State Water Resources Control Board

MERCED GROUNDWATER SUSTAINABILITY PLAN, GROUNDWATER SUBBASIN NO. 5-022.04

The State Water Resources Control Board (State Water Board) staff are providing these comments in support of the Department of Water Resources' (DWR) review of the Groundwater Sustainability Plan (GSP) for the Merced Groundwater Subbasin (subbasin).

Figure 1. 1,2,3-Trichloropropane in Merced Subbasin wells

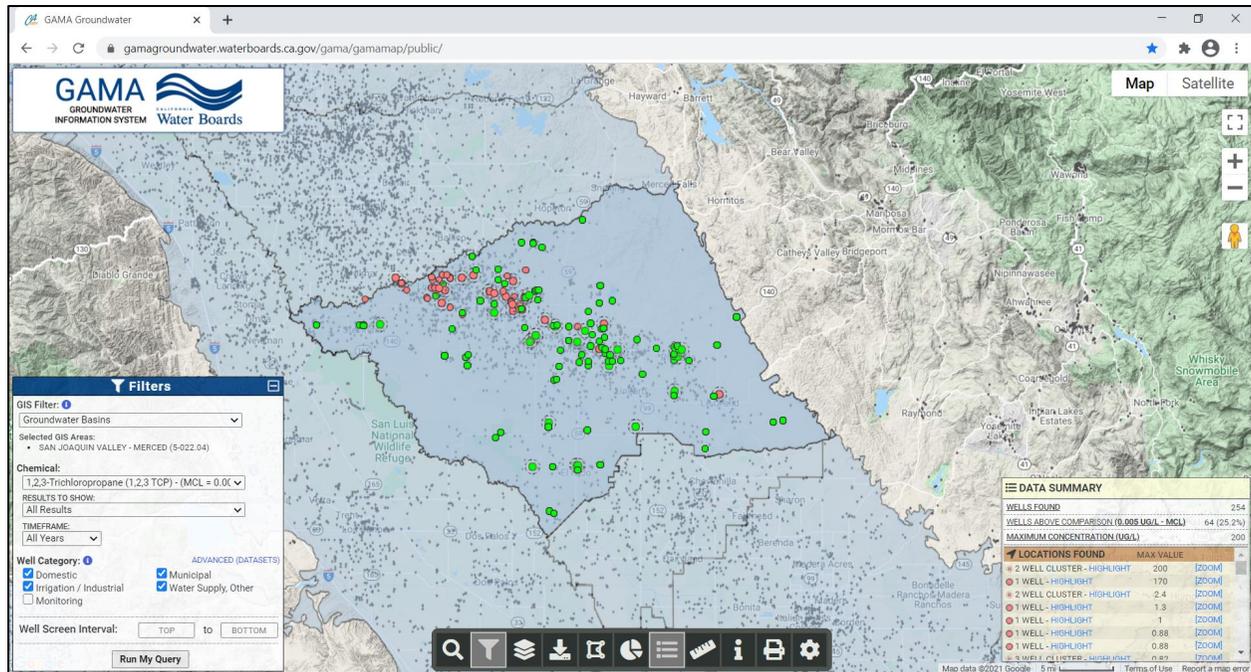
4. The GSP includes monitoring of a many groundwater quality constituents, but only defines SMC for salinity (as total dissolved solids). The GSP states that the “causal nexus between salinity and groundwater management activities has been established” (p. 3-12) but implies this nexus has not been established for other constituents. The GSP states that high salinity groundwater has been shown to migrate both from upwelling of deeper saline brines and across the subbasin due to groundwater pumping. However, groundwater pumping and projects and management actions under the GSAs’ authority may also have the potential to influence groundwater concentrations and distributions of widespread contaminants within the subbasin in addition to salinity. Based on their prevalence within the subbasin, GSP implementation should also include SMC for 1,2,3-trichloropropane (1,2,3-TCP), nitrate as nitrogen (nitrate), and arsenic. Staff have attached maps from the [State Water Board Groundwater Ambient Monitoring and Assessment \(GAMA\) Program’s database \(https://gamagroundwater.waterboards.ca.gov/\)](https://gamagroundwater.waterboards.ca.gov/) showing 1,2,3-TCP, nitrate, and arsenic impacts in subbasin groundwater (Figures 1, 2, and 3 in Appendix).

Not all water quality impacts to groundwater must be addressed in the GSP, but significant and unreasonable water quality degradation due to groundwater conditions occurring throughout the subbasin, and that were not present prior to January 1, 2015, must be addressed in the GSP’s minimum thresholds. Both groundwater extraction and the implementation of projects to achieve sustainability may cause impacts from migration of contaminant plumes, changes in the concentration of contaminants due to reduction in the volume of water stored in the subbasin, or release of harmful naturally occurring constituents. A GSA should particularly consider whether any groundwater quality constituents in the subbasin may impact the State’s policy of protecting the right of every human being to safe, clean, affordable, and accessible water adequate for human consumption, cooking, and sanitary purposes (Water Code, §106.3). Coordination by the GSAs with
